SUNDRY NOTICES AND REPORTS ON WELLS

Turner "A" #49

- ☐ Abandonment
☐ Recompletion
☐ Plugging Back
☐ Casing Repair
☐ Altering Casing
☐ Other _____
- ☒ Change of Plans
☐ New Construction
☐ Non-Routine Fracturing
☐ Water Shut-Off
☐ Conversion to Injection
☐ Dispose Water

RE: Turner "A" 49

Turnpike A #49

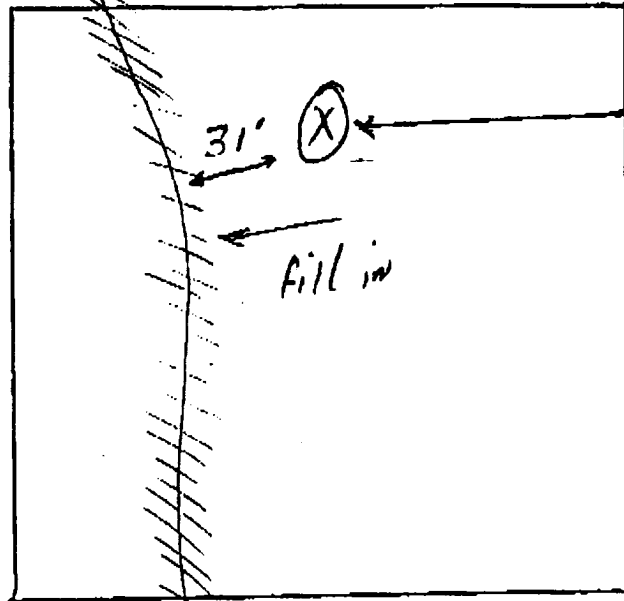
APD stipulations require the drainage ditch located 25' Southwest of the proposed well to be redirected around the location's West side. In order to take advantage of existing drainage, Devon proposes to redirect this drainage approximately 200' to the East through an existing canal (sketch attached).

This location was staked 31' East of an arroyo. The arroyo runs North and South crossing a lease road (road runs East and West) 150' North of the proposed well site. Diverting this arroyo to the East through an existing draw will stop the erosion running to the South. The diversion will be made 222' North East of the well site. A drawing of the well site is attached. This will also limit the water crossing the road once the natural drainage is in place to divert water 210' East of the well site.
